Access Compliance Report Public Rights-of-Way (Curb Ramps)

Main Street: REATA_RD		Cross Street: ORTEGA_HWY		Location:	NW
ADA ID: RPRK211118140504	Ramp Type: Type 1 - Perpendicular	Initial Pass/Fail: Pass	Overall Compliance: No	Severity Score:	22
Codes/Mitigation Info/Possible Solution			Field Measurements/Component Compliance

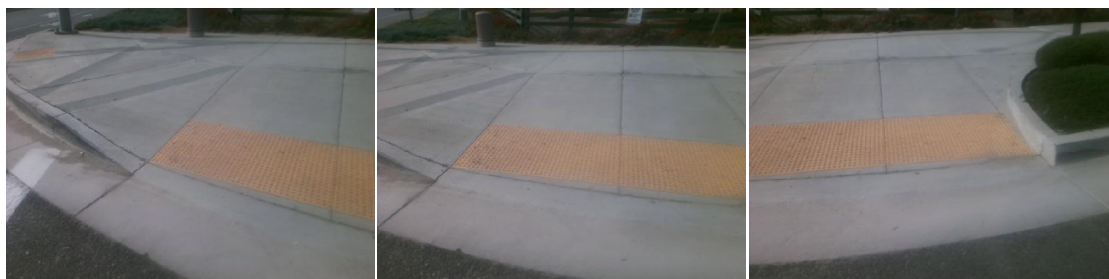
R304.2.2, R304.5.3, R304.2.3, STD 1115

Remove & Replace Entire Ramp.
